**SOUTH BURNETT  
REGIONAL COUNCIL**

## **Decision Notice**

Application No: MCU23/0012  
Street Address: 40 & 42 Markwell Street KINGAROY QLD 4610  
Real Property Description: Lot 107 & 108 on RP7914  
Planning Scheme: South Burnett Regional Council

Type of Decision: Approval  
Development Permit for Material Change of Use (8 x Multi Dwelling Units)  
Type of Approval: Date of Decision: 12 September 2023

**Unit Type D Floor Plan**  
Scale 1: 100

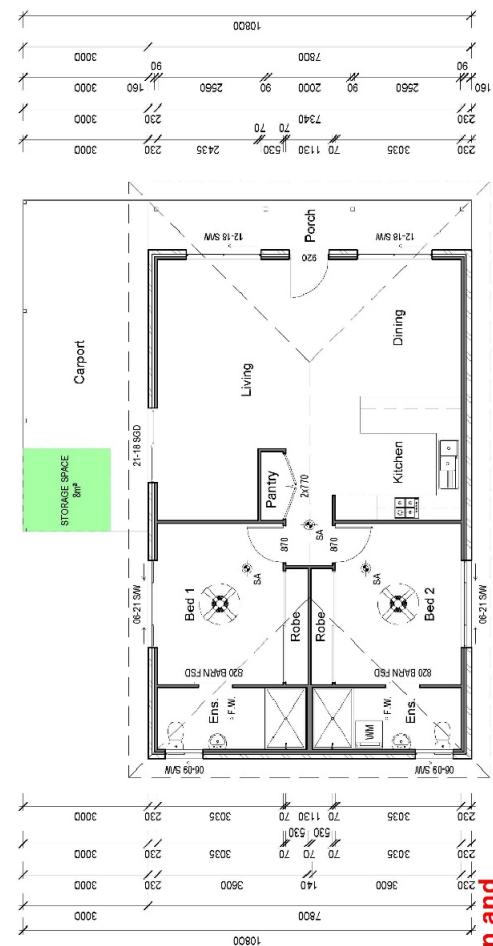
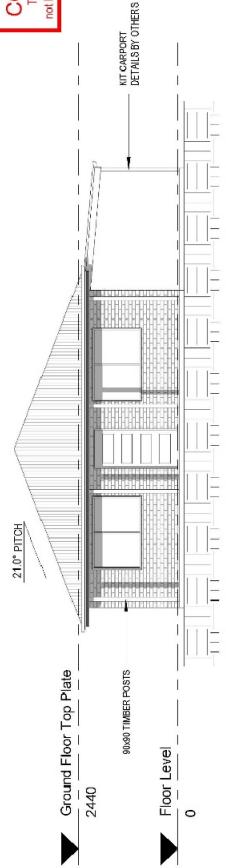
**AMENDMENTS:** Refer to Unit Type D Floor Plan (marked up in Red).

GEN8. Submit for Council's records a revised Floor Plan for Unit Type D showing a consistent orientation with that expressed on approved '*Site Plan 23-3304-SPY sheet 1 dated 19 July 2023*'.

**Unit Type D floor plan and  
carport orientation to be  
consistent with that shown on  
approved site plan.  
Amended in red 10.08.2023**
